ADDENDUM NUMBER THREE (3)

DATE: August 4, 2009

PROJECT: JOSEPH B. LANCASTER ELEMENTARY SCHOOL
ST. TAMMANY PARISH SCHOOL BOARD

SHEET NO. AD303		PROFESSIONAL OF RECORD	REVISED	DATE	PROJ. NO.
				06.25.09	0825
PROJECT: JOSEPH B. LANCASTER ELEMENTARY SCHOOL ST. TAMMANY PARISH SCHOOL BOARD MADISONVILLE, LOUISIANA STPSB PROJECT #0825		DRAWING NO. 0825-0825-0825 DATE: 08/25/2019 TIME: 11:00:00 AM

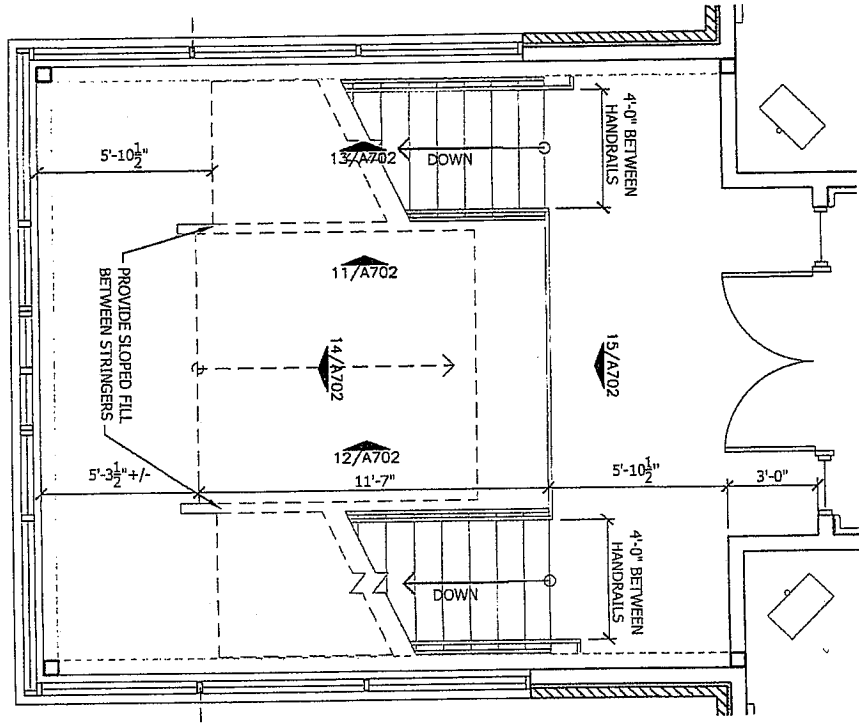
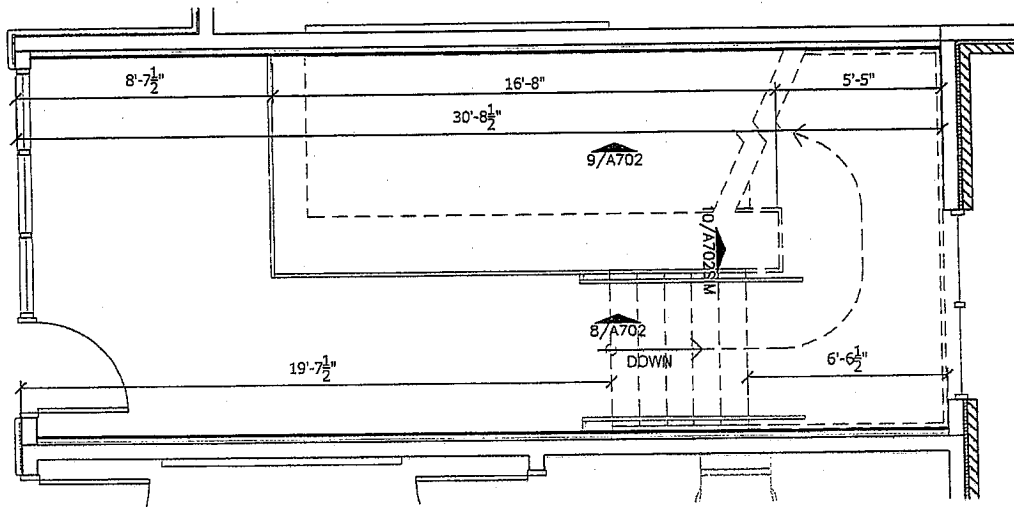
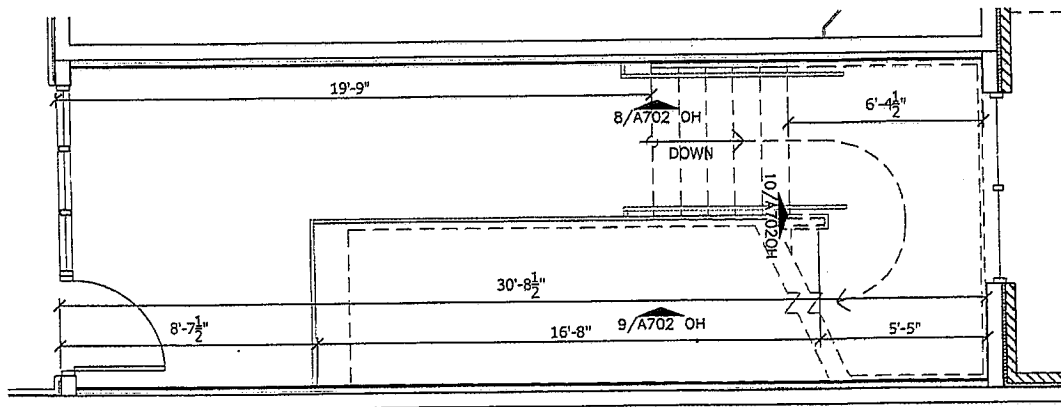
56. Refer to Sheet A701, Details 6, 9 and 10:
Delete these details in their entirety and replace with attached Drawing AD303, Details 1, 2 and 3.

2 WEST END ENTRY STREET BUFFER LANDSCAPING
1/16"=1'-0"

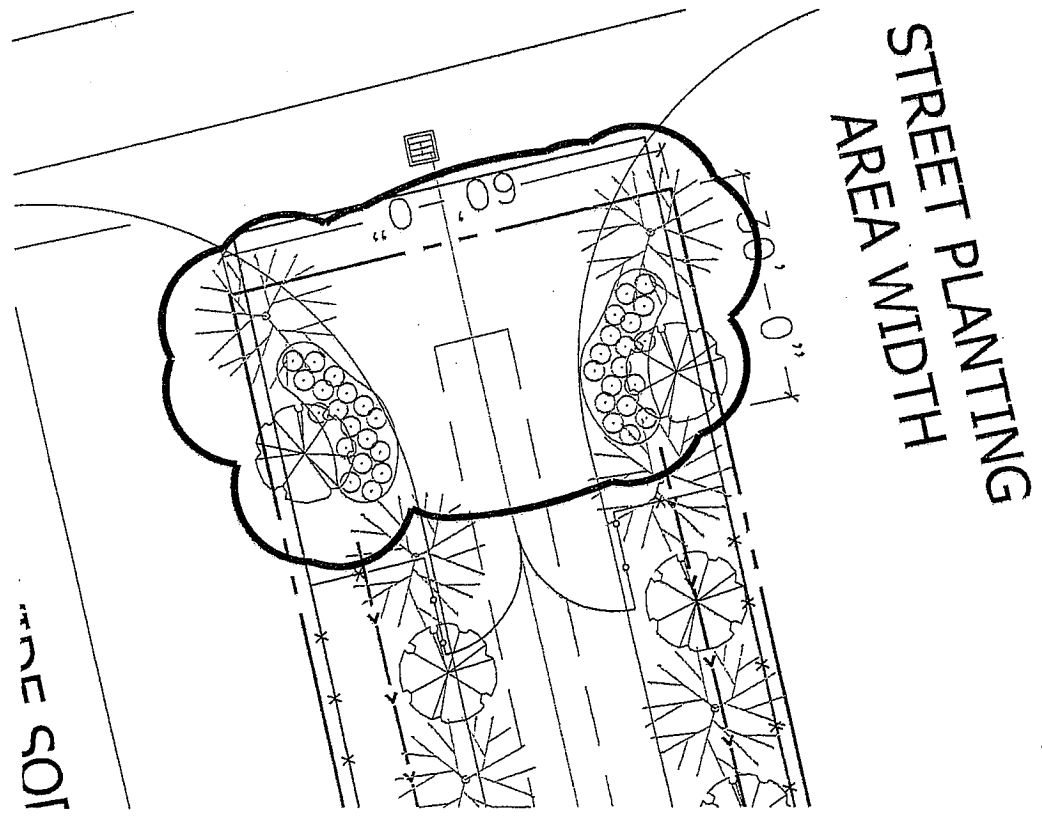
b. Delete Detail 2 and replace with Detail 2 on attached Drawing AD304 for changes to west entry landscaping.
c. Delete Detail 3 and replace with Detail 2 on attached Drawing AD305.

2 EAST END ENTRY STREET BUFFER LANDSCAPING
 1/16"=1'-0"

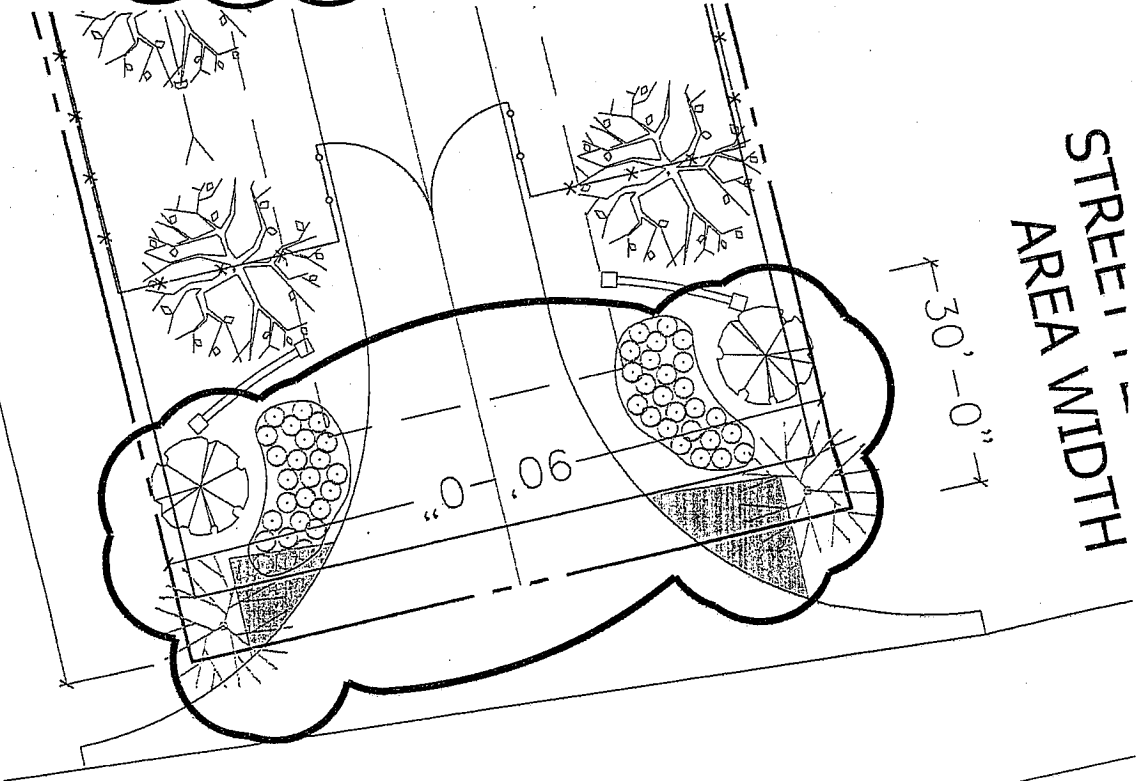
d. Refer to Planting Legend changes shown on Attached Drawing AD305.

TYPICAL HWY 22 WIDENING SECTION

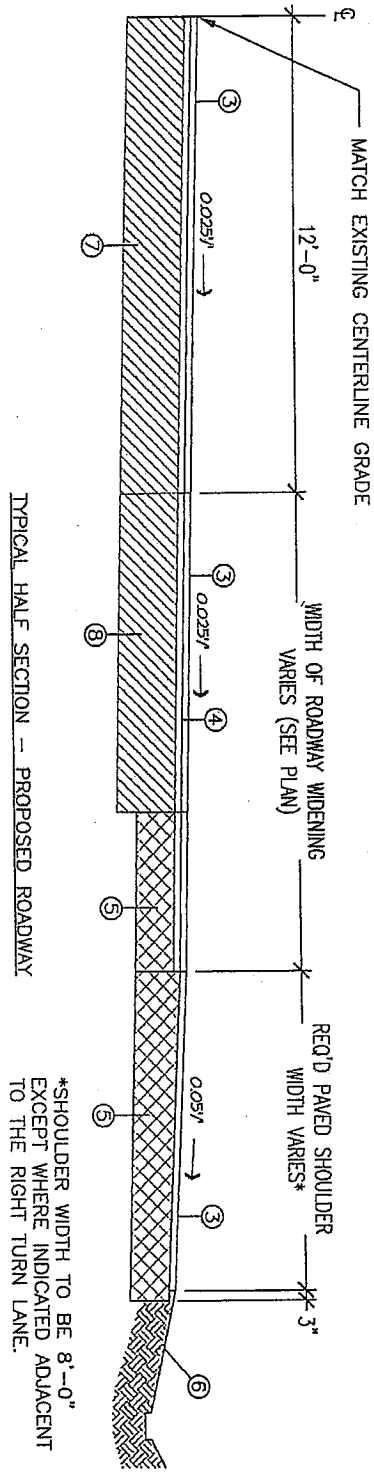
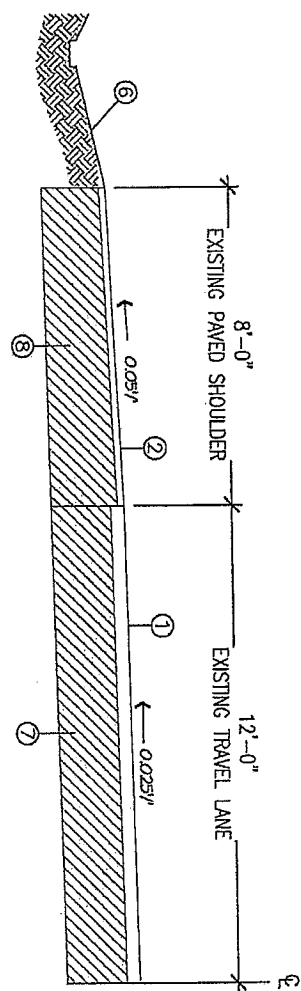
8. Refer to Sheet C125:
 - a. Remove the "Typical Hwy 22 Widening Section" shown on sketch ADC01 (issued with addendum #2) and replace with the "Typical Hwy 22 Widening Section" shown on attached sketch ADC04.

TYPICAL PINE CREEK DRIVE WIDENING SECTION
NOT TO SCALE

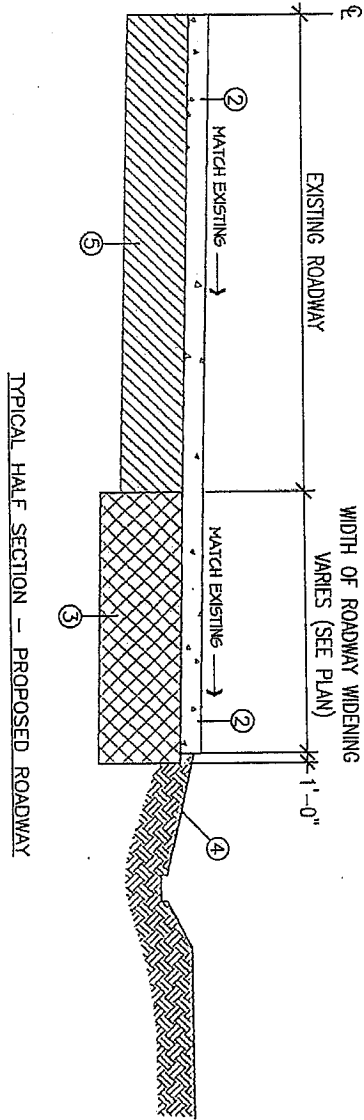
- b. Remove the "Typical Pine Creek Drive Widening Section" shown on sketch ADC02 (issued with addendum #2) and replace with the "Typical Pine Creek Drive Widening Section" shown on attached sketch ADC05.

PARTIAL 2nd FLOOR & LOWER ROOF FRAMING PLAN

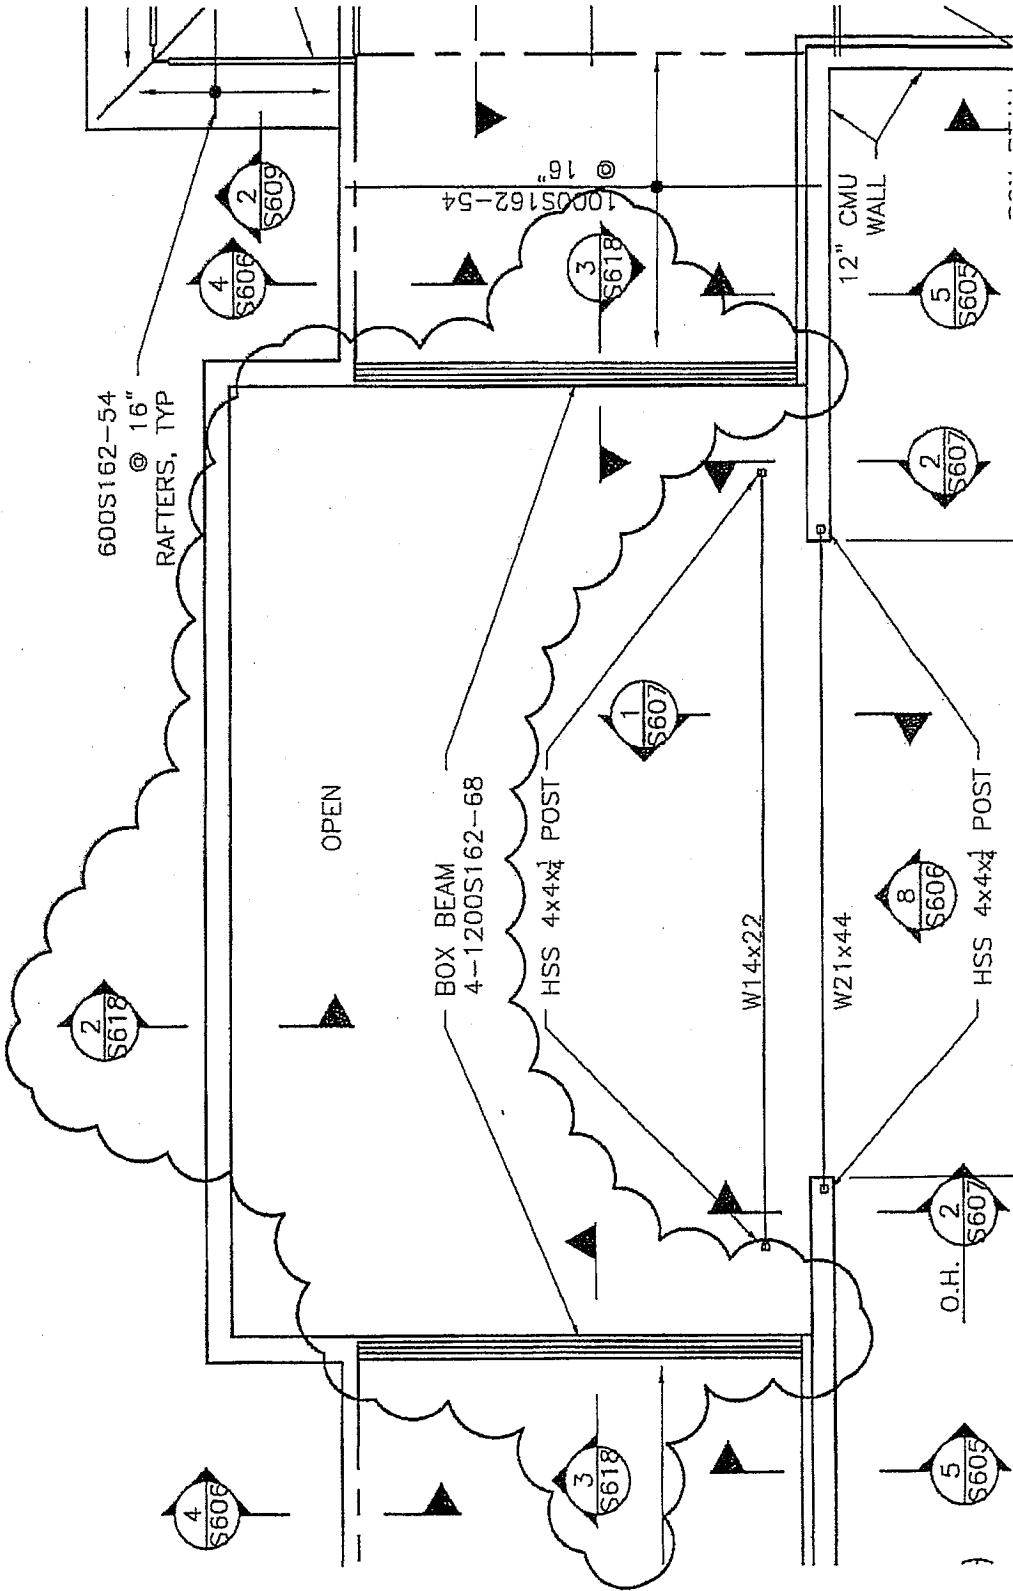
- a. Both shear walls at the southeastern exterior walls near the Locker Room and Dry Storage should be Type 3.
 - b. See attached sheet ADS07 for location of added 4-1200S162-68 box beams on either side of the Stage.

4 SECTION
S600
1" = 1'-0"

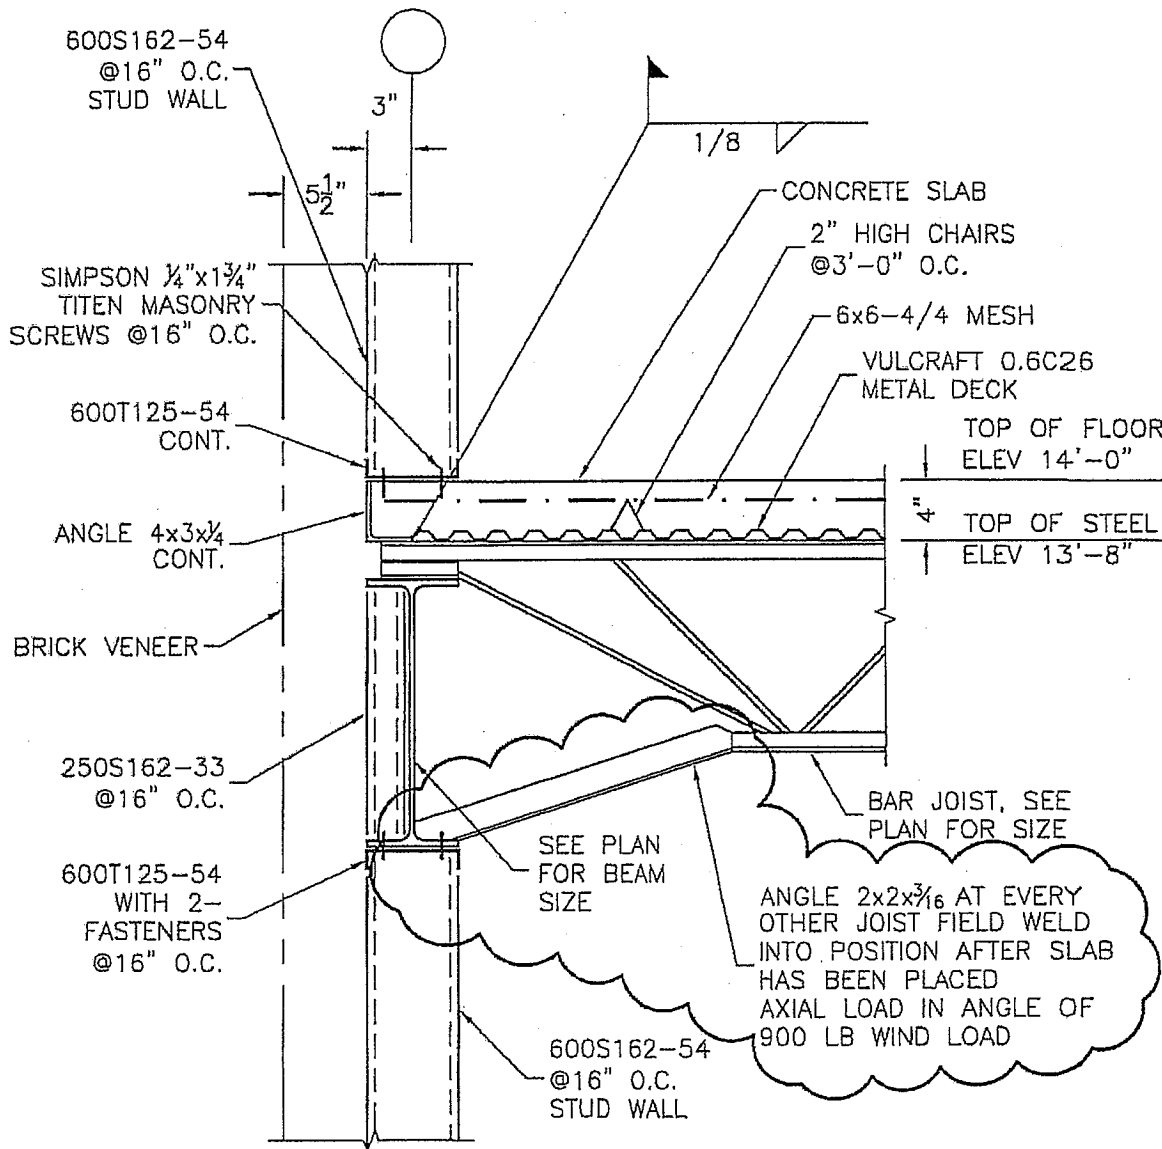
26. Refer to Sheet S600:
- a. Replace Section 4/S600 with revised Section 4/S600 on attached Sheet ADS08.
 - b. Replace section 5/S600 with revised section 5/S600 on attached Sheet ADS09.

LINTEL SCHEDULE

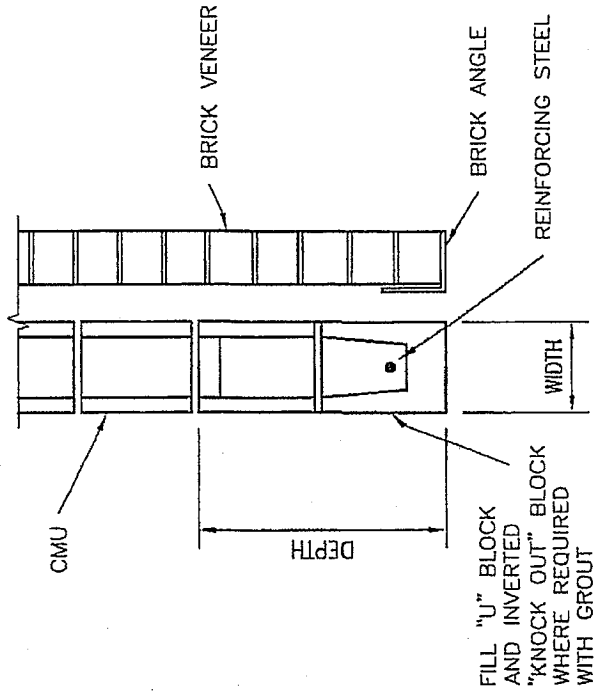
- b. Replace Lintel Schedule 10/S620 with revised Lintel Schedule 10/S620 on attached Sheet ADS13.

SINGLE PLATE CONNECTIONS

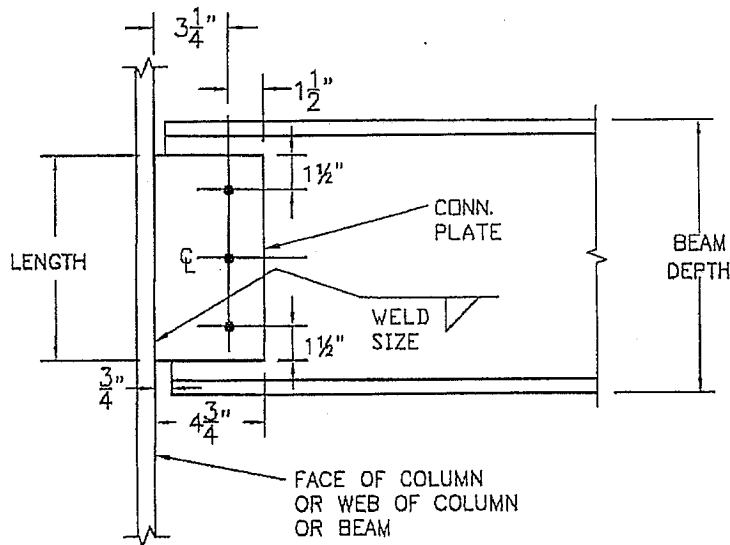
- b. Replace Single Plate Connection 7/S621 with Revised Single Plate Connection 7/S621 on attached Sheet ADS16.

1 FIN #1
Scale: 3/4"=1'-0"

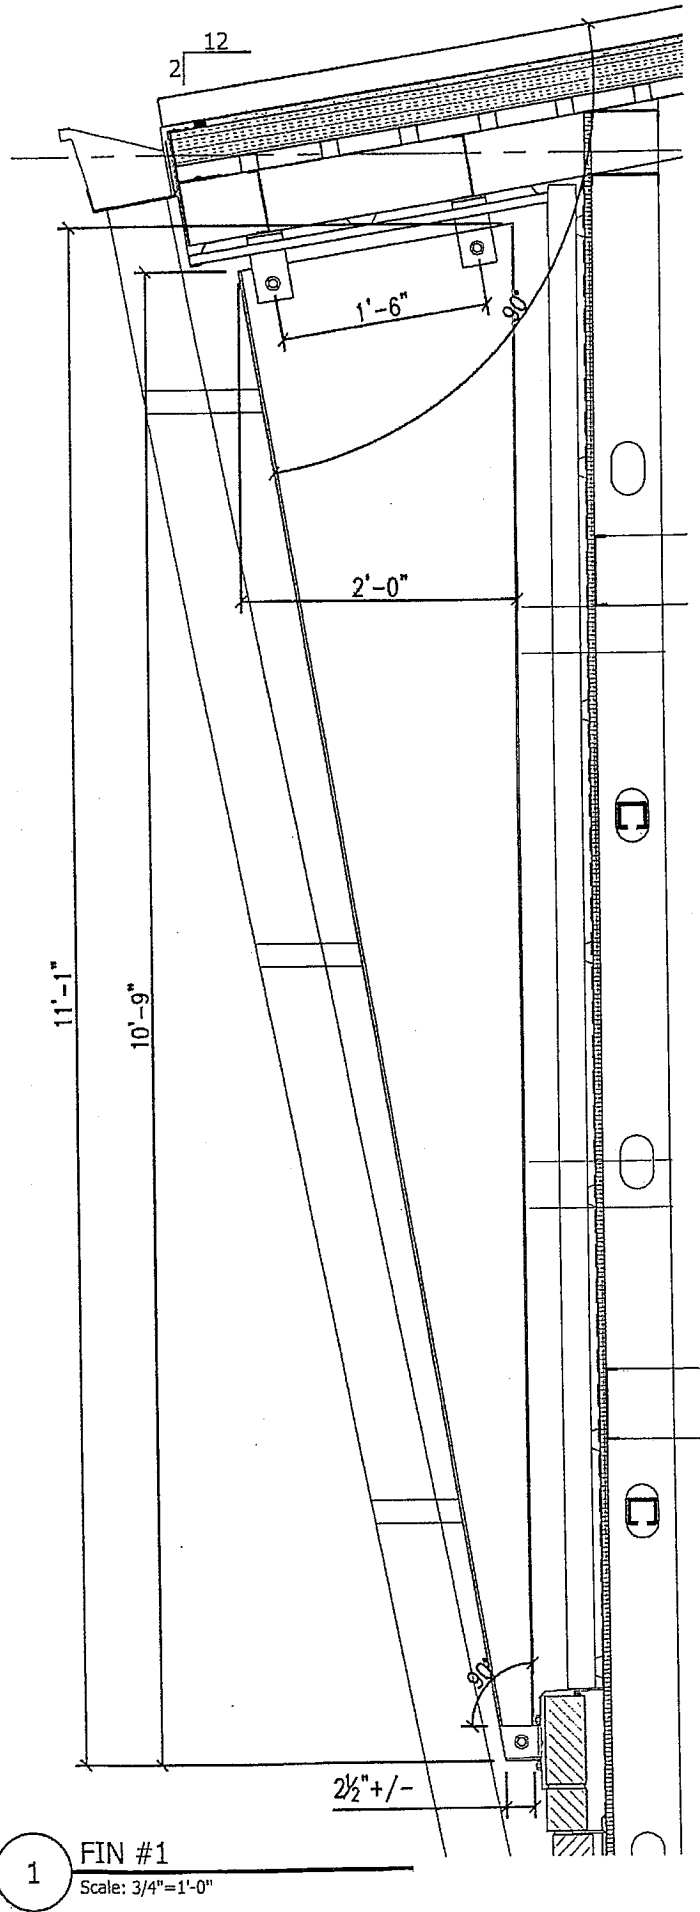
52. Refer to Detail 5/A315:
Delete Note "All top tracks to have 2" legs, typ." and replace with "Refer to Structural for all top track requirements".
53. Refer to Details 1 and 2/A318, Brackets (Fins):
See attached Drawings AD301 and AD302 for clarification of dimensions and materials.
